Origination Form
Proposed Revisions to a Standard Plans Index

Originator:	Rick Jenkins	Index Number:	520-020
Date:	2/24/2026	Sheet Number(s):	1
E-mail:	rick.jenkins@dot.state.fl.us	Index Title:	Traffic Separators

TYPE I - CONCRETE TRAFFIC SEPARATOR

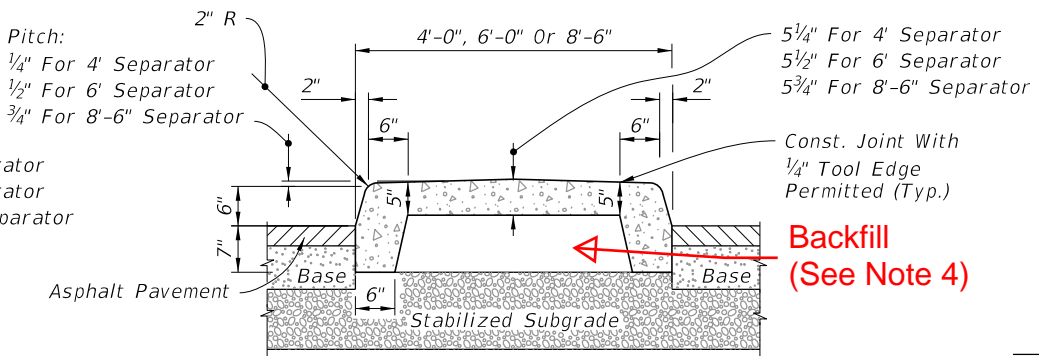
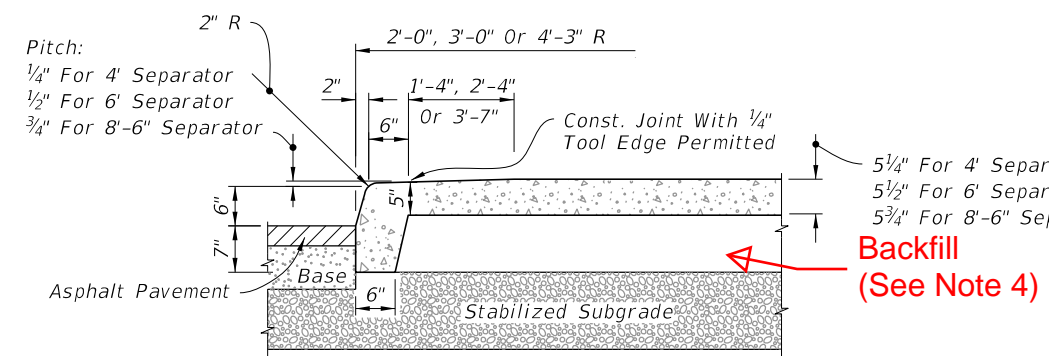
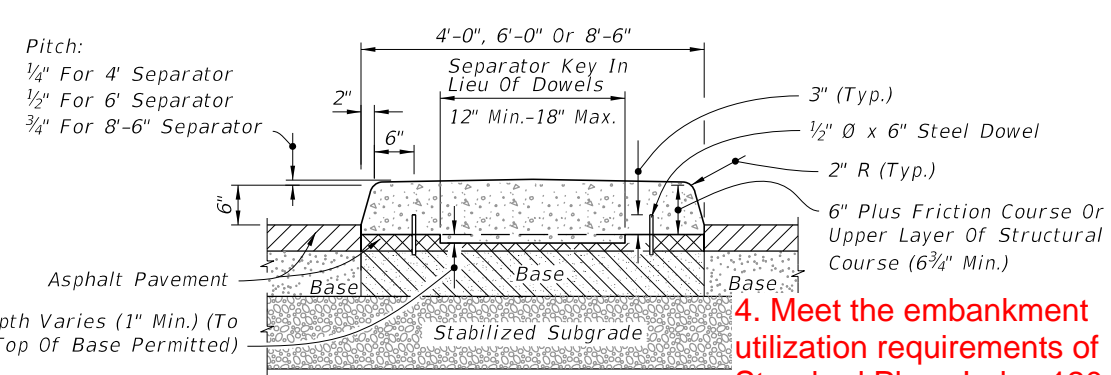
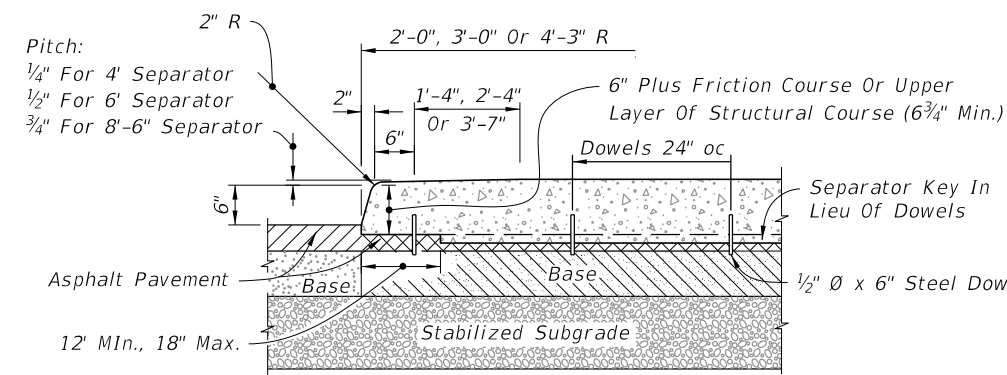
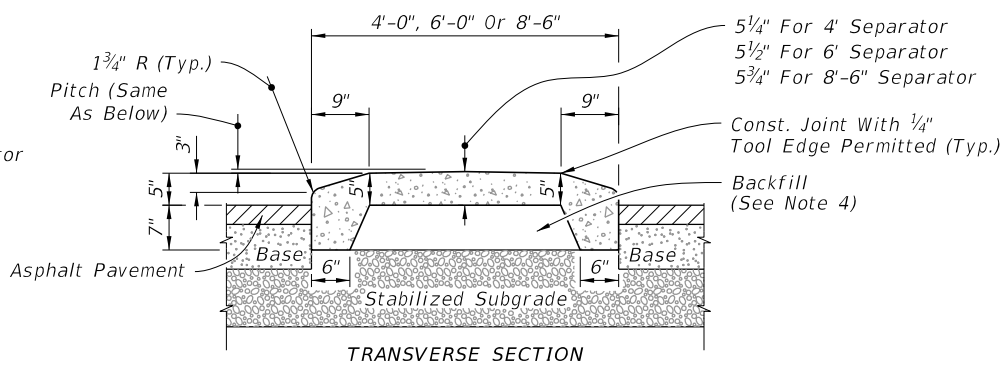
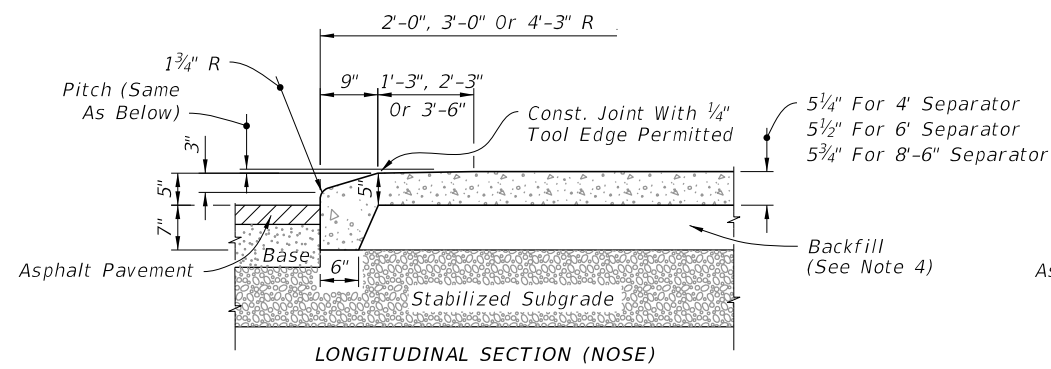
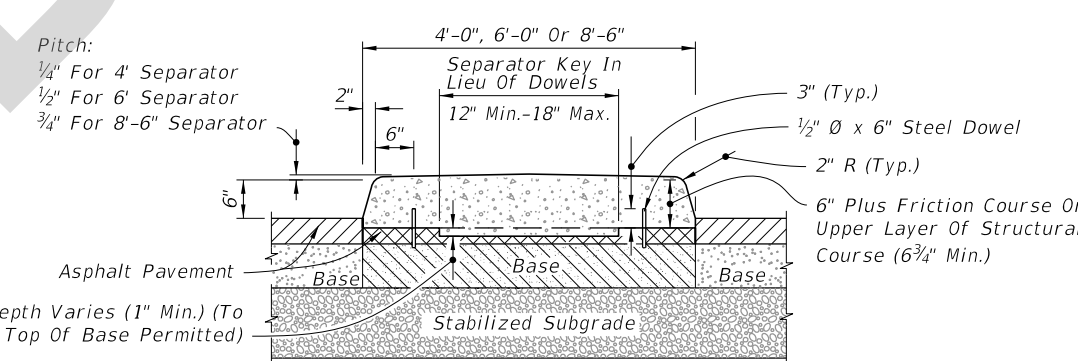
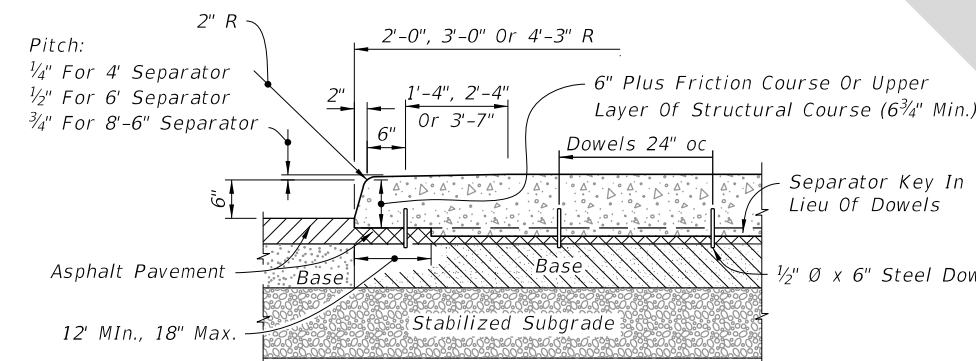
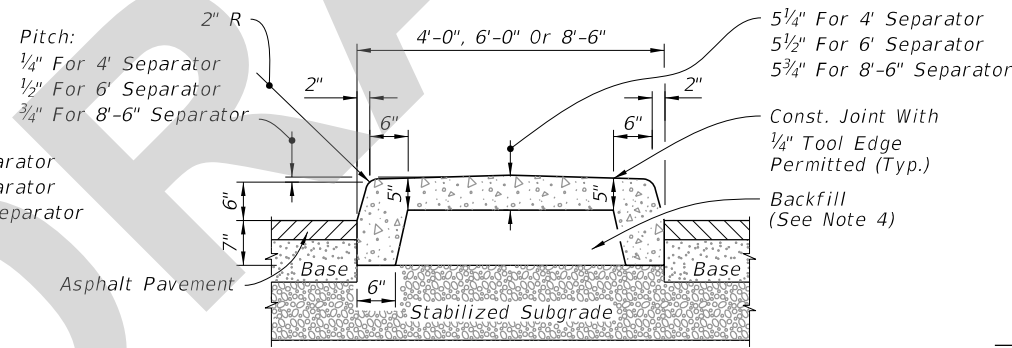
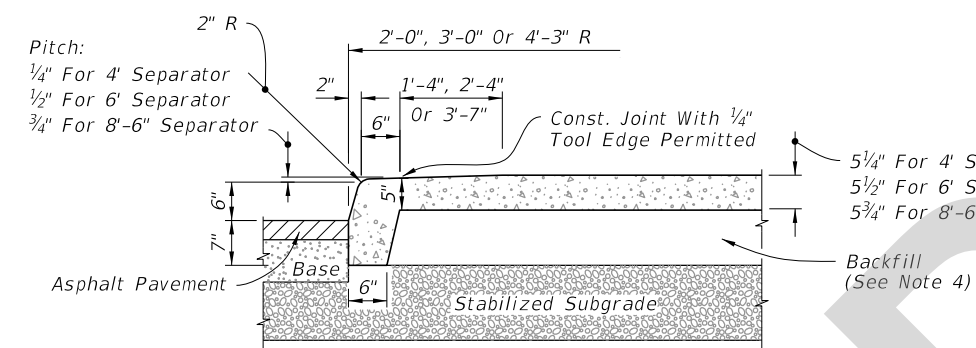
Sheet 1: In the "CONCRETE TRAFFIC SEPARATOR" details, added "Backfill (See Note 4)" callouts for all of the blank voids. Added Note 4 to explain the void fill requirements.

Districts commented that the voids were undefined on the Standard Plans sheet. This revision helps to clarify what goes in the voids and provides a reference to the corresponding Standard Plan.

4. Meet the embankment utilization requirements of Standard Plans Index 120-001.
